AR-07-0401

Southern Nuclear Operating Company
Vogtle Early Site Permit Application
Response to Requests for Additional Information Letter No. 3

Response to February 16, 2007 RAI Letter No. 3

Figure 1-4 Site Layout – New Development

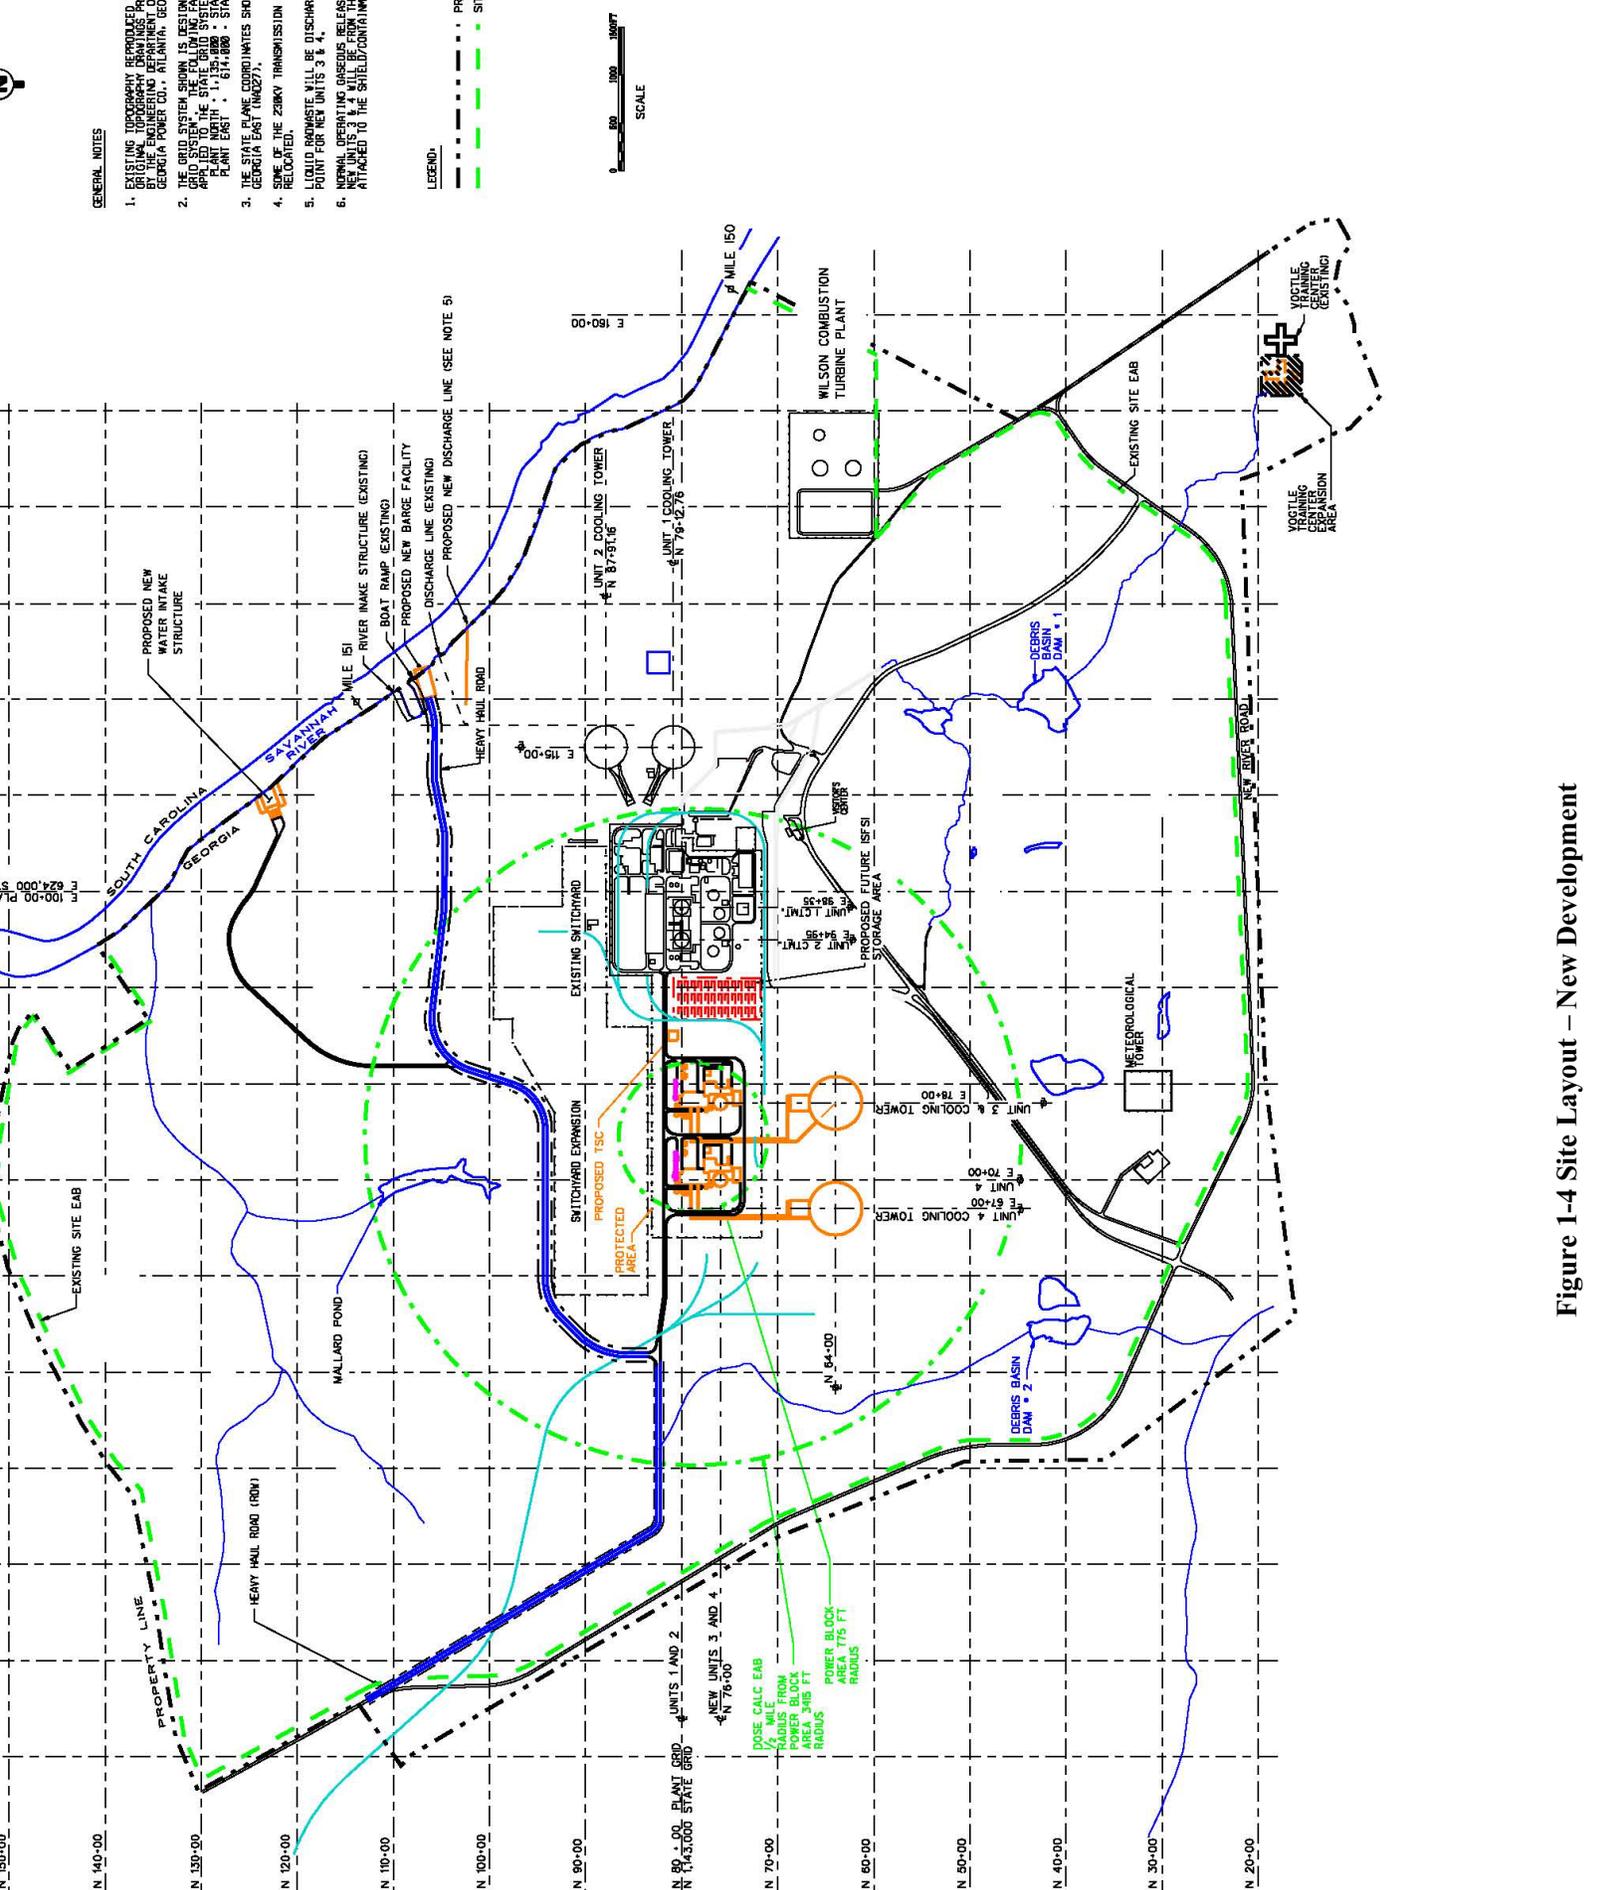
2.1.1-3 SSAR Figure 1-4, “Site Layout - New Development”, shows a map of the proposed units, the site boundary, and the exclusion area boundary (EAB) without a scale on the map. Please provide an updated SSAR Figure 1-4 that contains a scale for that Figure.

2.1.2-2 Provide more details regarding the location of the visitor center, including a site map that shows the location of it.

SSAR Figure 1-4 has been revised to show a scale for the new development map. This revised figure is included for your review and will be incorporated into the next revision to the ESP application.

SSAR Figure 1-4 has been revised to show the visitors center. Refer to the Response to RAI 2.1.1-3 for this revised Figure.
